SUBJECT: Beaver Valley Power Station - Unit No. 2  
Docket No. 50-412  
Electrical Separation Criteria

The attached information is provided to close outstanding issues related to Regulatory Guide 1.75 electrical separation at BVPS-2. This attachment consists of the following information:

2. FSAR changes based on this test program including:

- ° FSAR 1.8 (Regulatory Guide Position)
- ° FSAR 8.3.1.4 (Independence of Redundant Systems)
- ° FSAR Figures 8.3-16 through 8.3-73

FIGURE 8.3-16  
GENERAL PLANT AREAS (GPA)  
ACCEPTABLE SEPARATION  
ARRANGEMENTS  
BEAVER VALLEY POWER STATION-UNIT 2  
FINAL SAFETY ANALYSIS REPORT

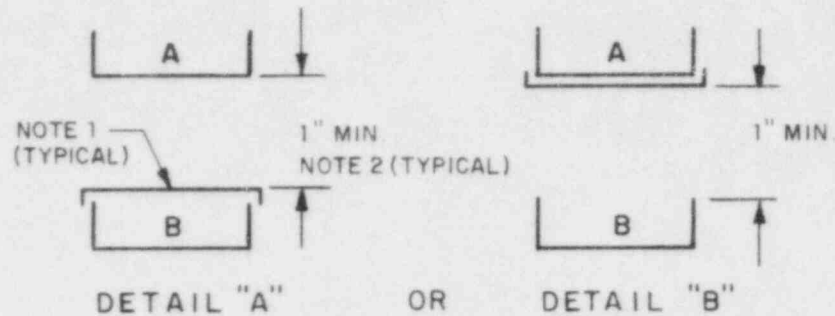
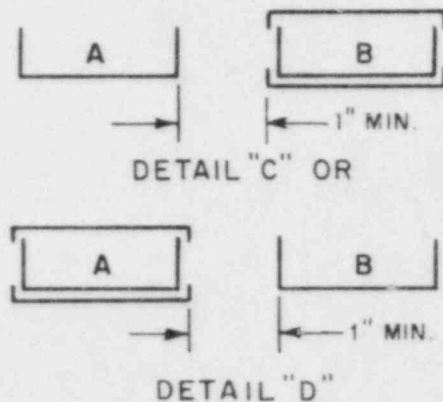
In the GPA, where a 1 in. minimum vertical free air space is maintained between redundant Class 1E trays, a tray cover on the top of the lower tray or a tray cover on the bottom of the upper tray is installed as shown on Figure 8.3-16, Details A and B.

In the GPA, where a 1 in. minimum horizontal free air space is maintained between redundant Class 1E trays, tray covers top and bottom of one of the trays are installed as shown on Figure 8.3-16, Details C and D.

FIGURE 8.3-17  
GENERAL PLANT AREAS (GPA)  
ACCEPTABLE SEPARATION  
ARRANGEMENTS  
BEAVER VALLEY POWER STATION-UNIT 2  
FINAL SAFETY ANALYSIS REPORT

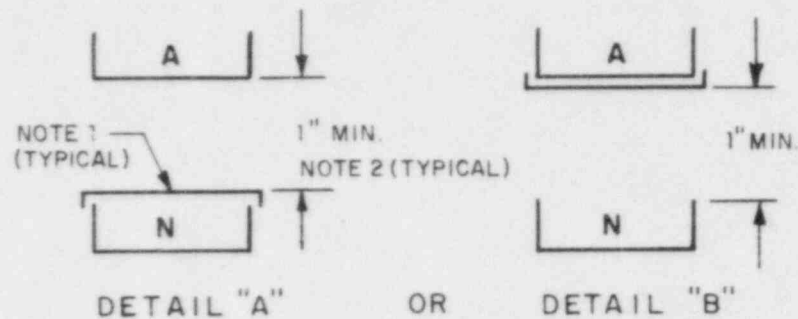
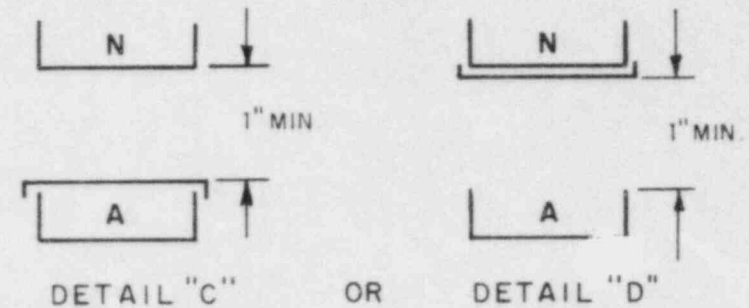
In the GPA, where a 1 in. minimum vertical free air space is maintained between non-Class 1E and Class 1E, a tray cover on the top of the lower tray or a tray cover on the bottom of the upper tray is installed as shown on Figure 8.3-17, Details A, B, C, and D.

In the GPA, where a 1 in. minimum horizontal free air space is maintained between non-Class 1E and Class 1E trays, tray covers on the top and bottom of one of the trays are installed as shown on Figure 8.3-17, Details E and F.

FIGURE 8.3-24

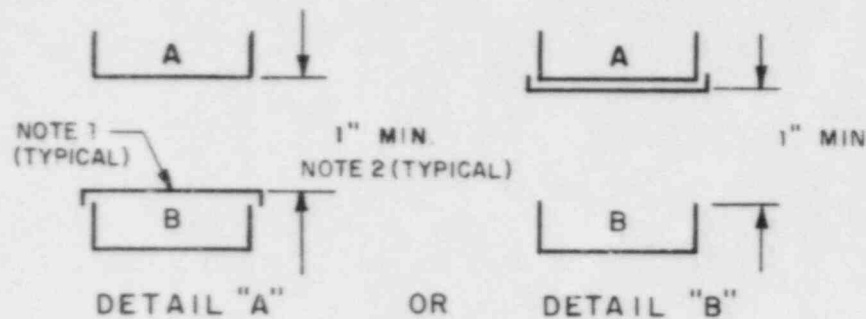
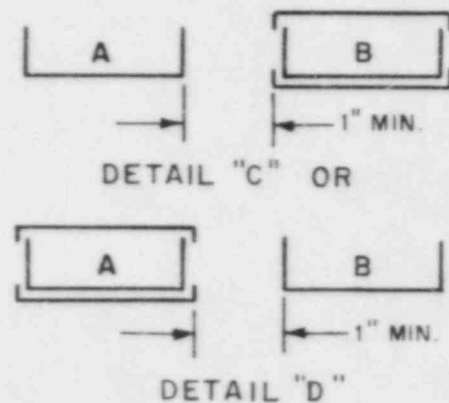
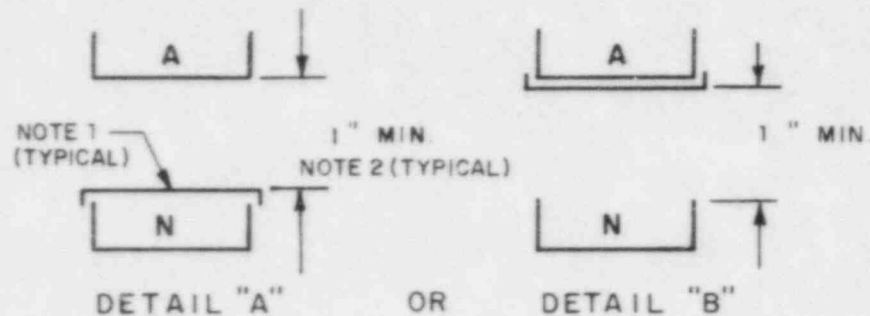
In the CSA, where a 1 in. minimum vertical free air space is maintained between redundant Class 1E trays, a tray cover on the bottom of the upper tray or on the top of the lower tray is installed as shown on Figure 8.3-24, Details A and B.

In the CSA, where a 1 in. minimum horizontal free air space is maintained between redundant Class 1E trays, tray covers on the top and bottom of one of the trays are installed as shown on Figure 8.3-24, Details C and D.

FIGURE 8.3-25

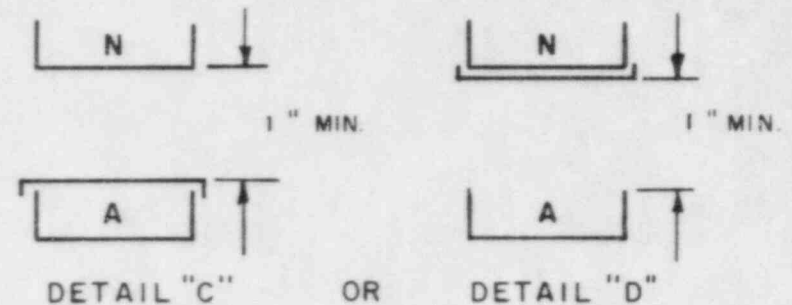
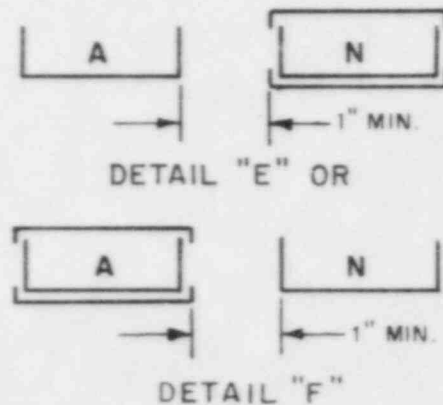
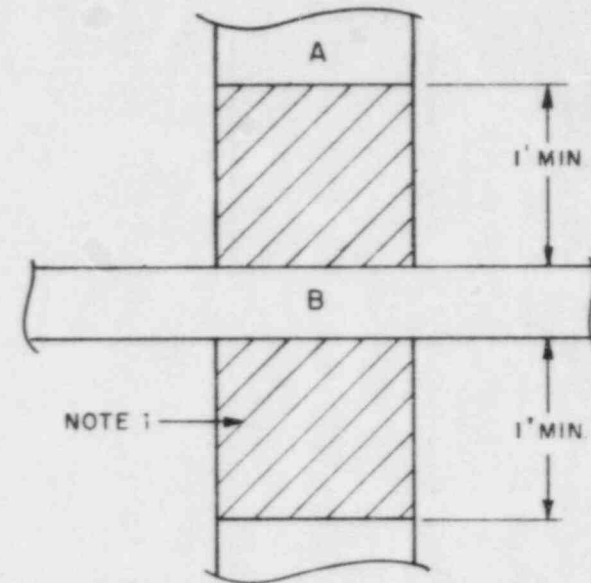
In the CSA, where a 1 in. minimum vertical free air space is maintained between a non-Class 1E tray and a Class 1E tray, a tray cover on the bottom of the upper tray or a tray cover on the top of the lower tray is installed as shown on Figure 8.3-25, Details A, B, C, and D.

In the CSA, where a 1 in. minimum horizontal free air space is maintained between non-Class 1E and Class 1E trays, tray covers on the top and bottom of one of the trays are installed as shown on Figure 8.3-25, Details E and F.

FIGURE 8.3-32

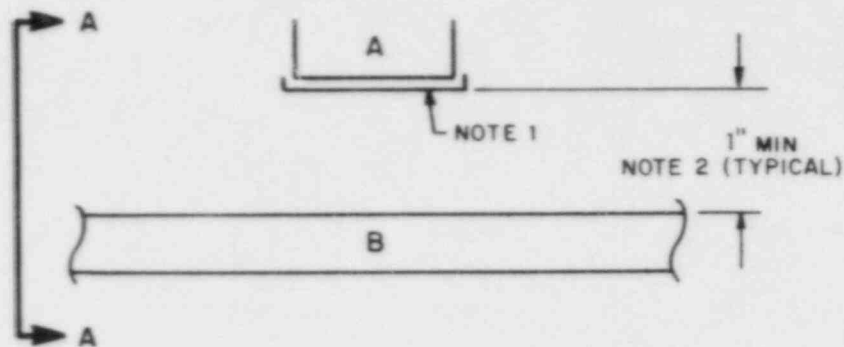
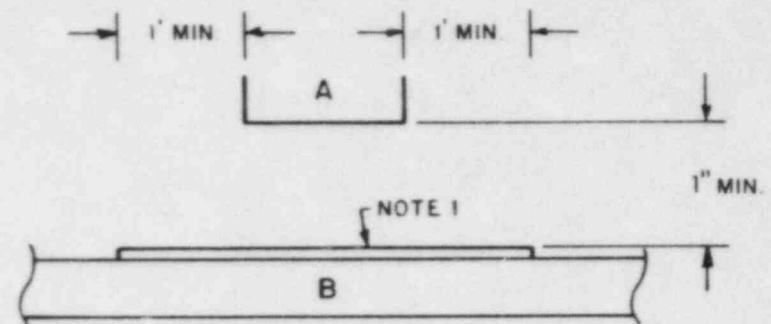
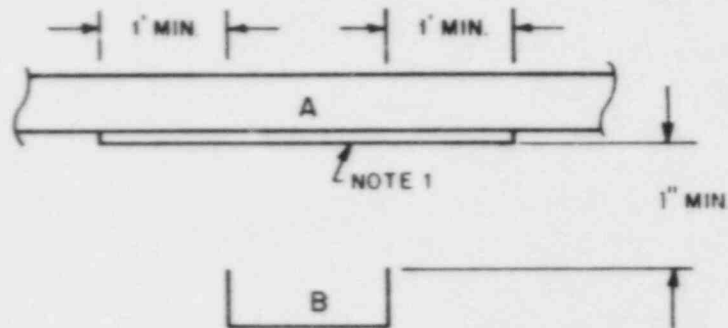
In the GPA, where a 1 in. minimum vertical free air space is maintained between a Class 1E tray and a redundant Class 1E tray which cross in a vertical plane, a tray cover on the top of the lower tray or on the bottom of the upper tray is installed as shown of Figure 8.3-32.

**FIGURE 8.3-33**

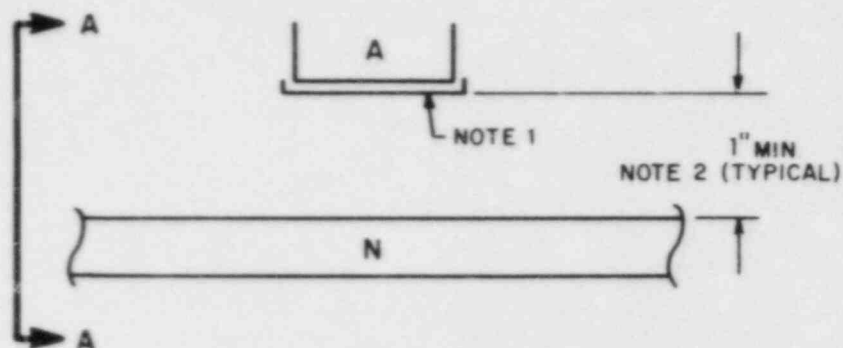
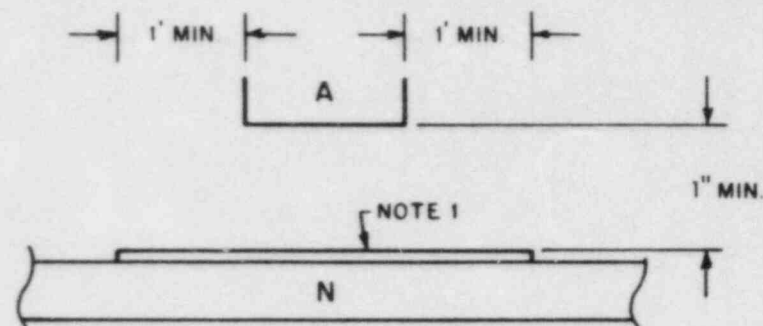
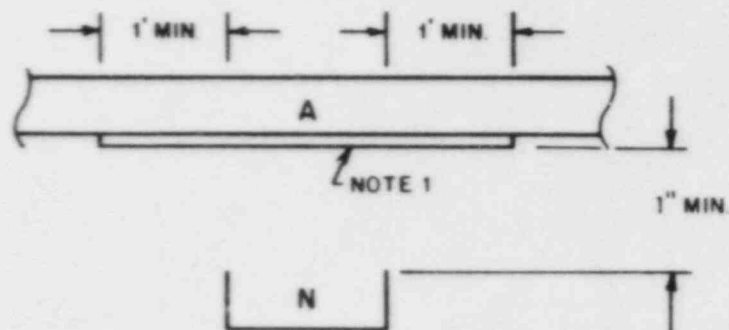
In the GPA, where a 1 in. minimum vertical free air space is maintained between a Class 1E tray and a non-Class 1E tray which cross in a vertical plane, a tray cover on the top of the lower tray or on the bottom of the upper tray is installed as shown on Figure 8.3-33.

FIGURE 8.3-34  
GENERAL PLANT AREAS (GPA)  
ACCEPTABLE SEPARATION  
ARRANGEMENTS  
BEAVER VALLEY POWER STATION-UNIT 2  
FINAL SAFETY ANALYSIS REPORT

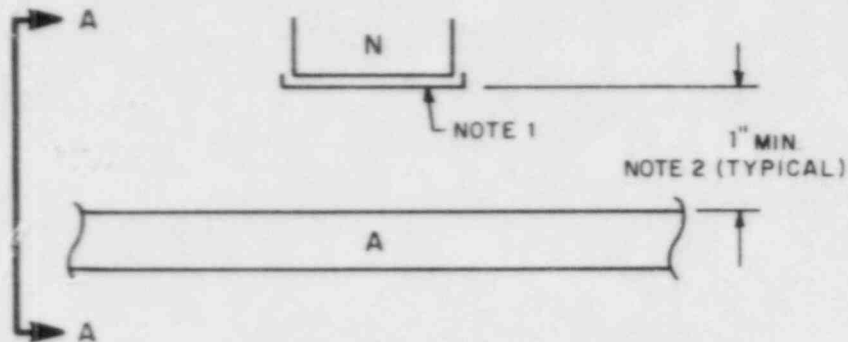
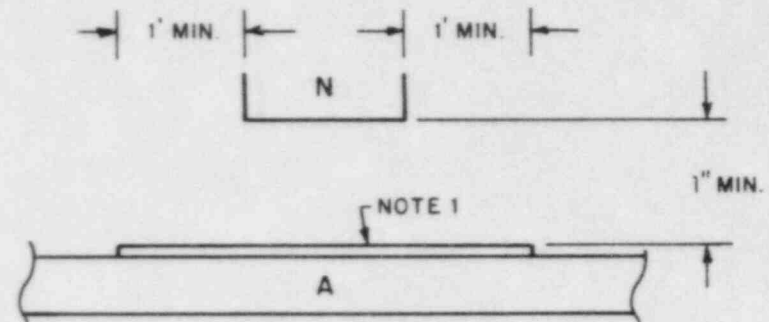
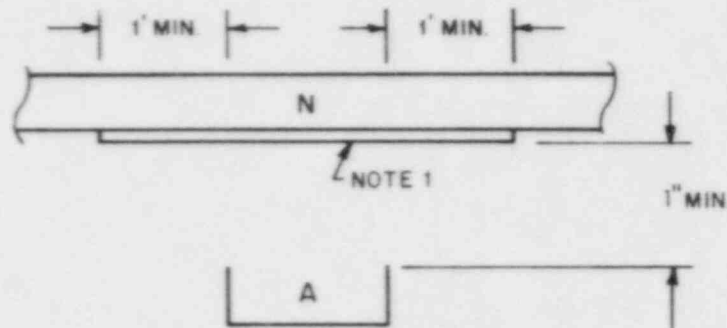
In the GPA, where a 1 in. minimum vertical free air space is maintained between a non-Class 1E tray and a Class 1E tray which cross in a vertical plane, a tray cover on the top of the lower tray or on the bottom of the upper tray is installed as shown on Figure 8.3-34

**FIGURE 8.3-35  
CABLE SPREADING AREAS (CSA)  
ACCEPTABLE SEPARATION  
ARRANGEMENTS  
BEAVER VALLEY POWER STATION-UNIT 2  
FINAL SAFETY ANALYSIS REPORT**

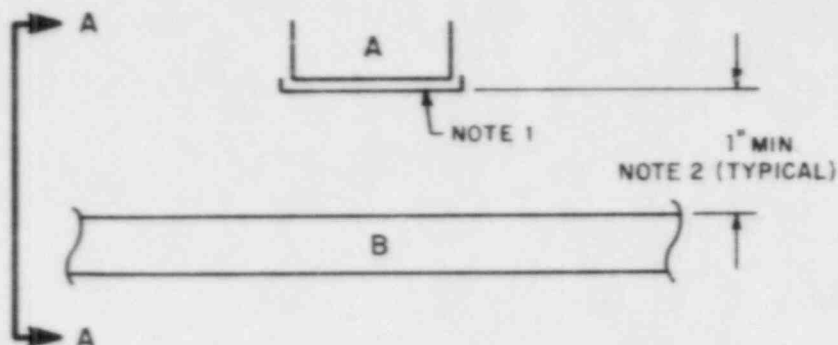
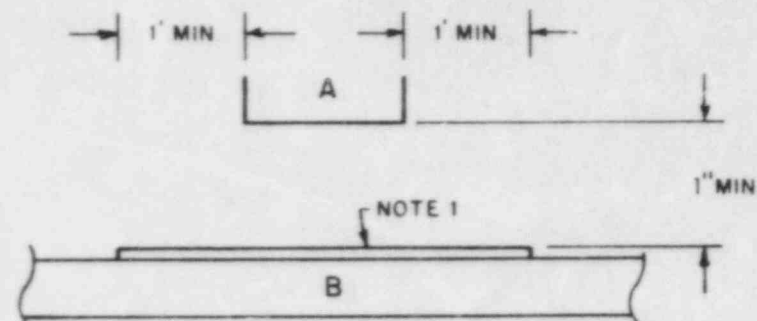
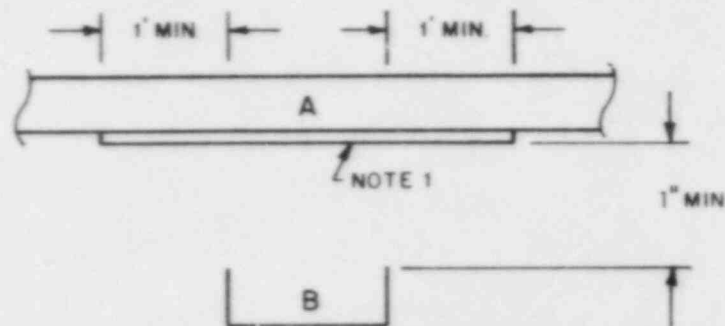
In the CSA, where a 1 in. minimum vertical free air space is maintained between a Class 1E tray and a redundant Class 1E tray which cross in vertical plane, a tray cover on the top of the

lower tray or on the bottom of the upper tray is installed as shown on Figure 8.3-35.

**FIGURE 8.3-36  
CABLE SPREADING AREAS (CSA)  
ACCEPTABLE SEPARATION  
ARRANGEMENTS  
BEAVER VALLEY POWER STATION-UNIT 2  
FINAL SAFETY ANALYSIS REPORT**

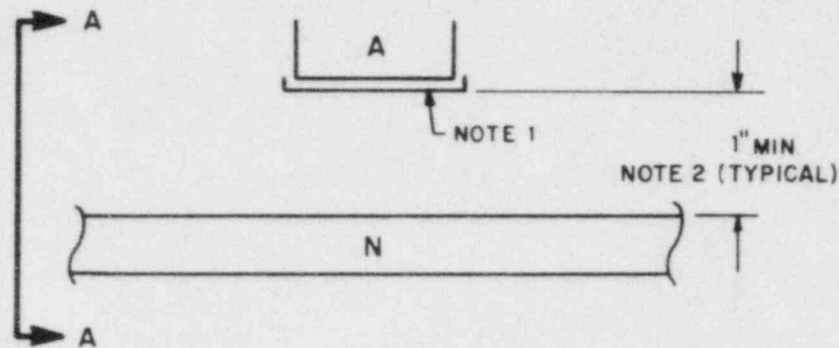
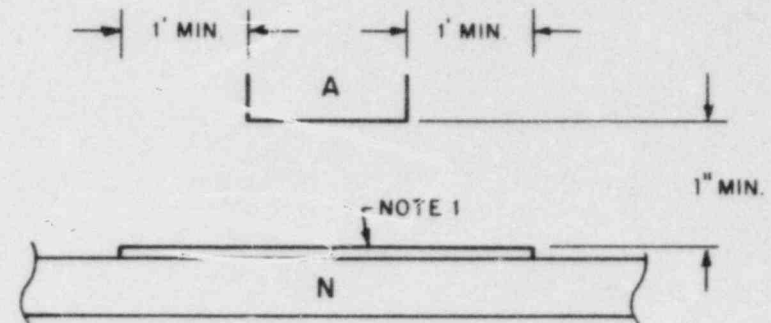
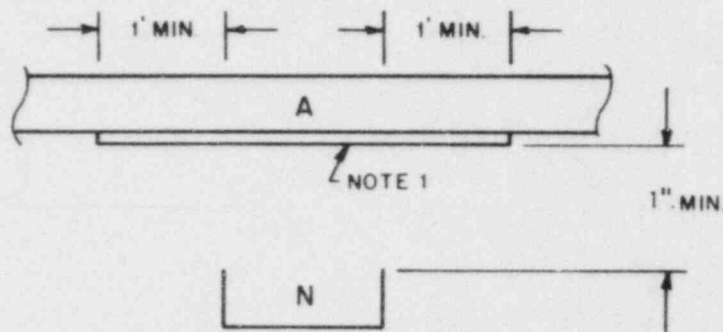
In the CSA, where a 1 in. minimum vertical free air space is maintained between a Class 1E tray and a non-Class 1E tray which cross in a vertical plane, a tray cover on the top of the lower tray or on the bottom of the upper tray is installed as shown on Figure 8.3-36.

FIGURE 8.3-37

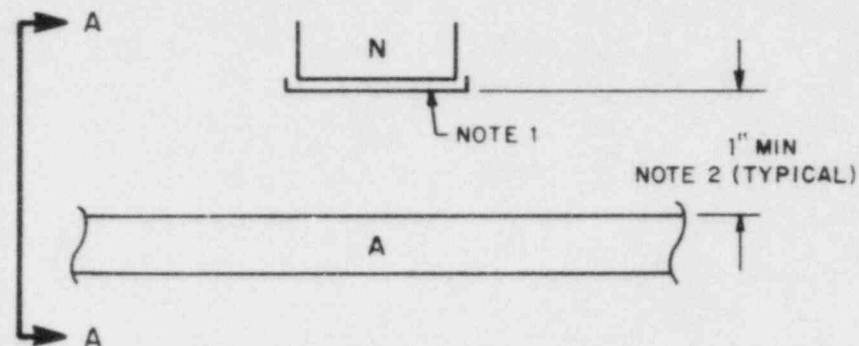
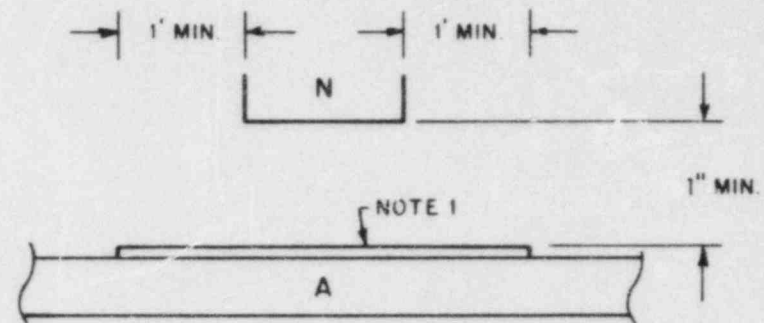
In the CSA, where a 1 in. minimum vertical free air space is maintained between a non-Class 1E and a Class 1E tray which cross in a vertical plane, a tray cover on the top of the lower tray or on the bottom of the upper tray is installed as shown on Figure 8.3-37.

FIGURE 8.3-46

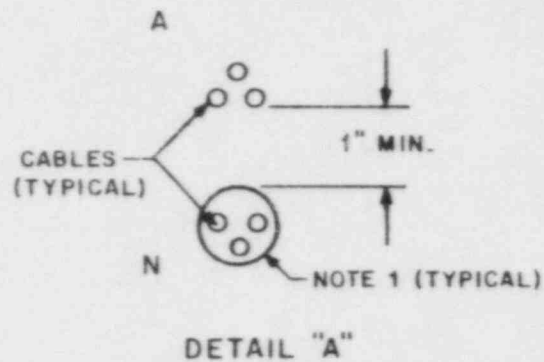
In the GPA, where cables are appropriately grouped together and the non-Class 1E group is installed in conduit or enclosed in a protective wrap, separation between the Class 1E cables and the non-Class 1E cables may be reduced to 1 in. as shown on Figure 8.3-46, Details A, B, and C.

FIGURE 8.3-49

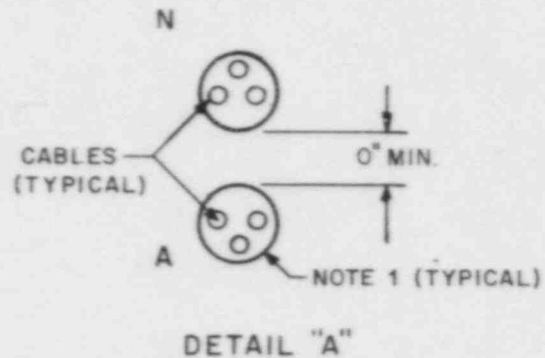
In the GPA, where cables are appropriately grouped together and are enclosed in a protective wrap, separation between non-Class 1E cables and Class 1E cables may be reduced to 0 in. as shown on Figure 8.3-49, Details A, B, and C.

FIGURE 8.3-50

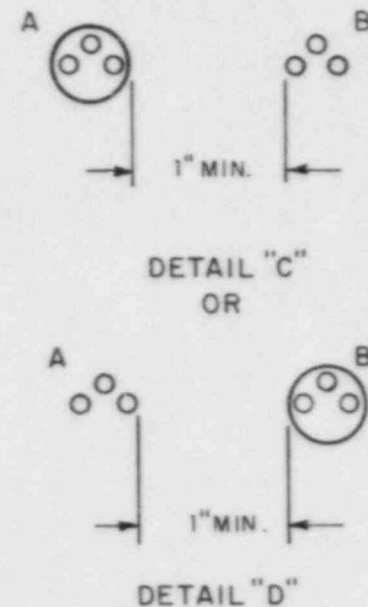
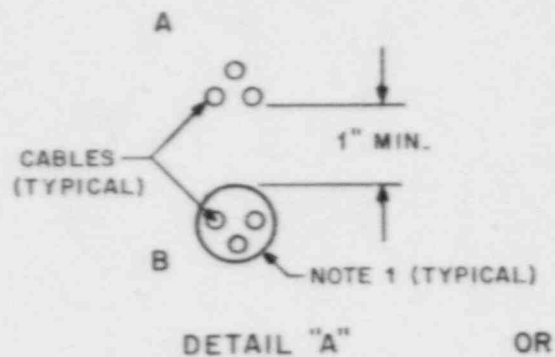
In the CSA, where cables are appropriately grouped together and either Class 1E group is installed in a conduit or enclosed in a protective wrap, separation between redundant Class 1E cables may be reduced to 1 in. as shown on Figure 8.3-50, Details A, B, C, and D.

FIGURE 8.3-52

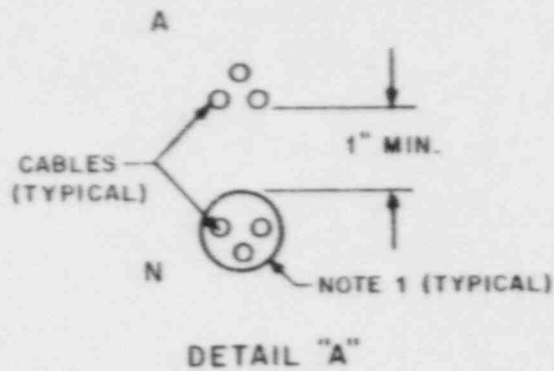
In the CSA, where cables are appropriately grouped together and the non-Class 1E group is installed in conduit or enclosed in a protective wrap, separation between the Class 1E cables and the non-Class 1E cables may be reduced to 1 in. as shown on Figure 8.3-52, Details A, B, and C.

FIGURE 8.3-53

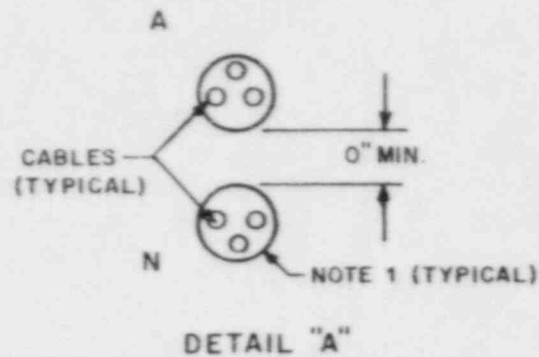
In the CSA, where cables are appropriately grouped together and are enclosed in a protective wrap, separation between Class 1E cables and non-Class 1E cables may be reduced to 0 in. as shown on Figure 8.3-53, Details A, B, and C.

FIGURE 8.3-54

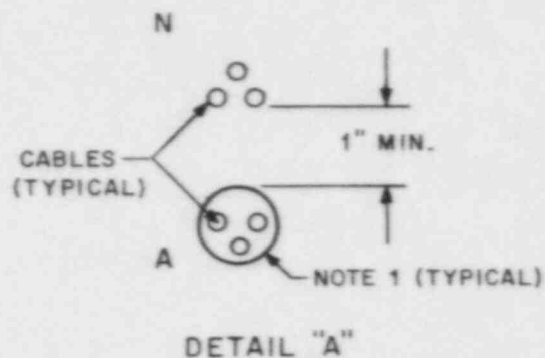
In the CSA, where cables are appropriately grouped together and the Class 1E group is installed in conduit or enclosed in a protective wrap, separation between the non-Class 1E cables and the Class 1E cables may be reduced to 1 in. as shown on Figure 8.3-54, Details A, B, and C.

FIGURE 8.3-56

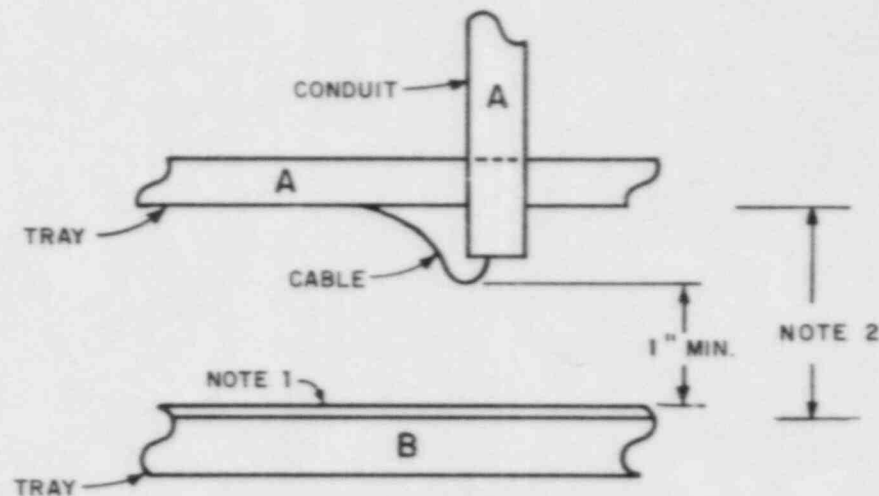
In the GPA, where a 1 in. minimum vertical free air space is maintained between redundant Class 1E trays and a tray cover is provided in accordance with Figure 8.3-16, Detail A, where a cable enters the upper tray, separation between the Class 1E cable and the redundant Class 1E tray may be reduced to 1 in. as shown on Figure 8.3-56.

FIGURE 8.3-57  
GENERAL PLANT AREAS (GPA)  
ACCEPTABLE SEPARATION  
ARRANGEMENT  
BEAVER VALLEY POWER STATION-UNIT 2  
FINAL SAFETY ANALYSIS REPORT

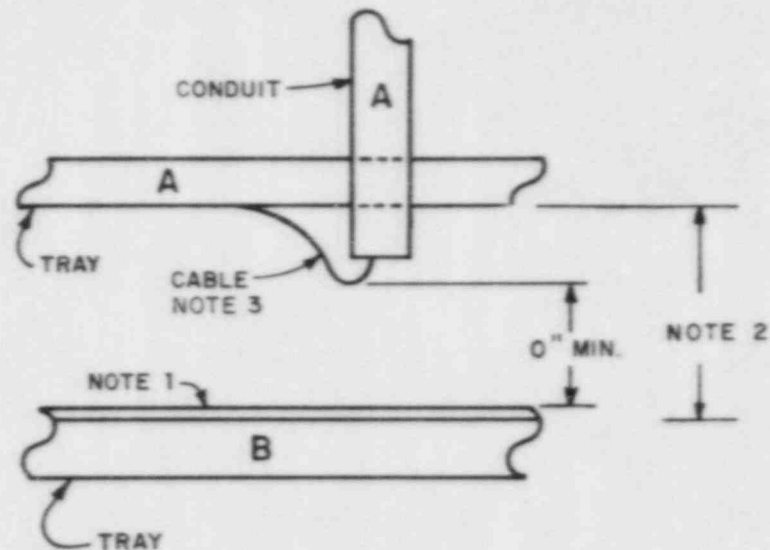
In the GPA, where a 1 in. minimum vertical free air space is maintained between redundant Class 1E trays and a tray cover is provided in accordance with Figure 8.3-16, Detail A, where a cable enters the upper tray and is enclosed in a protective wrap, separation between the Class 1E cable and the redundant Class 1E cable tray may be reduced to 0 in. as shown on Figure 8.3-57.

FIGURE 8.3-58

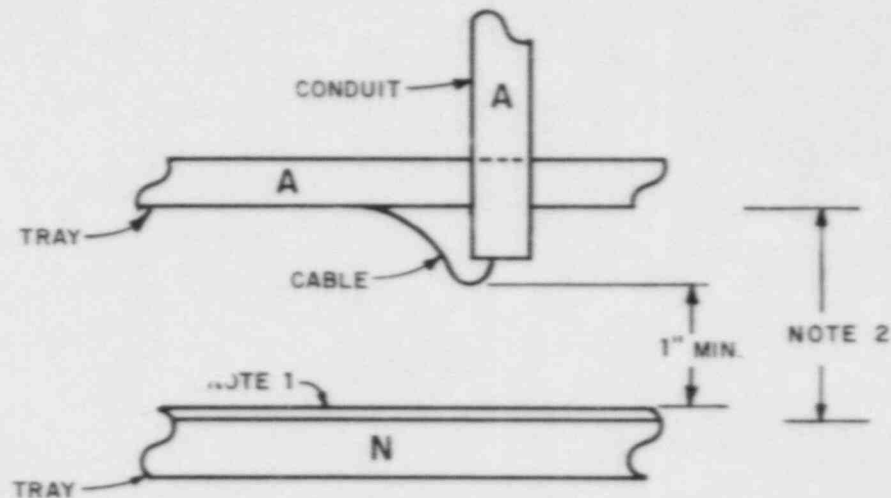
In the GPA, where a 1 in. minimum vertical free air space between Class 1E and non-Class 1E trays is maintained and a tray cover is provided in accordance with Figure 8.3-17, Detail A, where a Class 1E cable enters the Class 1E tray, separation between the Class 1E cable and the non-Class 1E tray may be reduced to 1 in. as shown on Figure 8.3-58.
